MEMORANDUM

REVIEW TYPE: Preliminary Plan of Subdivision

PROJECT NAME: B. F. Gilberts Subdivision of Takoma Park

CASE #: 120090340

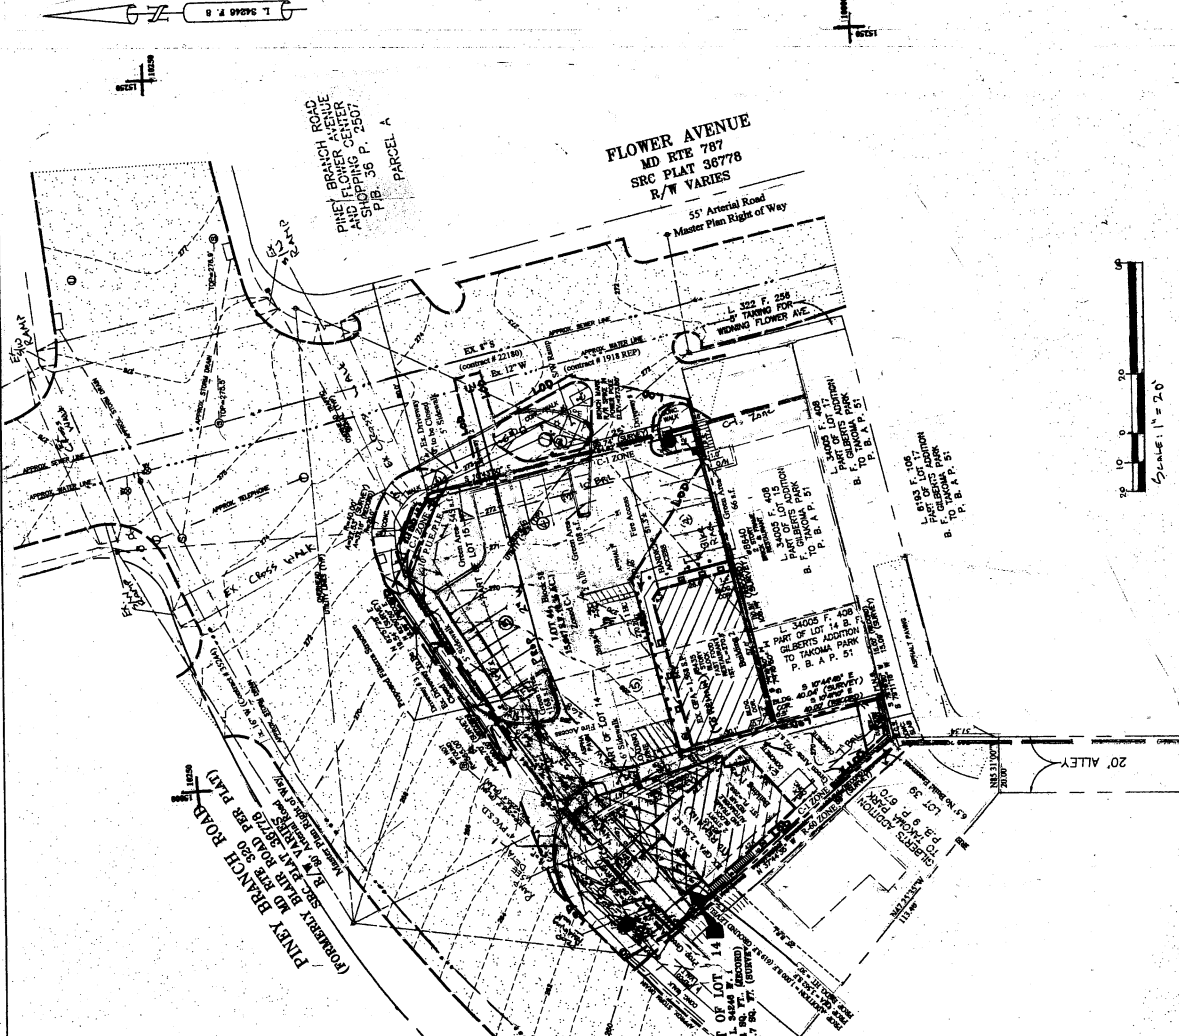
1. The building entrance does not appear to be accessible, as required by the Americans with Disabilities Act.
2. The sidewalk system is incomplete.
3. It does not appear that the property meets the current requirements for eight percent green space.

4. The relocation of the dumpster from the rear to the front of the property puts the dumpster next to the accessible walkway and entrance. This is very poor design with potentially bad effects. No enclosure design for this dumpster is shown. The required enclosure appears to interfere with the accessible walkway and entrance.

5. Dumpster pickup can only be accessed by a truck backing across two lanes of traffic on Piney Branch Road into a driveway. This is a very dangerous situation given the amount of traffic on Piney Branch and the fact that this property is located around a curve that obstructs visibility for drivers heading east.

6. Driveway 2 is located 35 feet from the intersection and 20 feet from the crosswalk. This is too close to the intersection and compromises pedestrian and traffic safety.

7. Parking is proposed right up to the new sidewalk on Piney Branch. There needs to be a five-foot buffer between the sidewalk and the designated parking area.
8. Driveway 4 is 26 feet wide. This is too wide and impacts pedestrian safety.
9. Driveway 4 has a 15-foot radius. This is much too wide for a driveway and compromises the accessible curb ramp that must be installed there.
10. One *van-accessible* parking space is required to meet ADA and 59-E-2.23 of Montgomery County Zoning Code and the Accessible Parking Spaces requirements of the State of Maryland. There is no van-accessible space shown on the plan. The only handicapped space shown is not van accessible and appears to be only 16 ft. long instead of 18 ft.

The other four parking spaces adjacent to the “handicap” space shown also appear to be only 16 feet long instead of the 8.5 ft by 18 ft. as required by 59-E-2.22.

- The existing access openings along MD 320 (eastern access) and MD 787 (northern access) must be closed due to their close proximity to the intersection.
- The existing access along MD 320 and MD 787 that will remain must be revised to have 30' radii.
- The area just west of the MD 320 access must be regraded, have trees and brush removed, and have a new retaining wall constructed so that this area is clear and sight distance can be improved.
- Other right of way improvements as required by SHA must be made and all improvements must be permitted by the Engineering Access Permits Division. An access permit must be obtained prior to issuing any building permits.
- Based on the above comments and conditions, this project has preliminary plan approval and can move forward in the planning process.
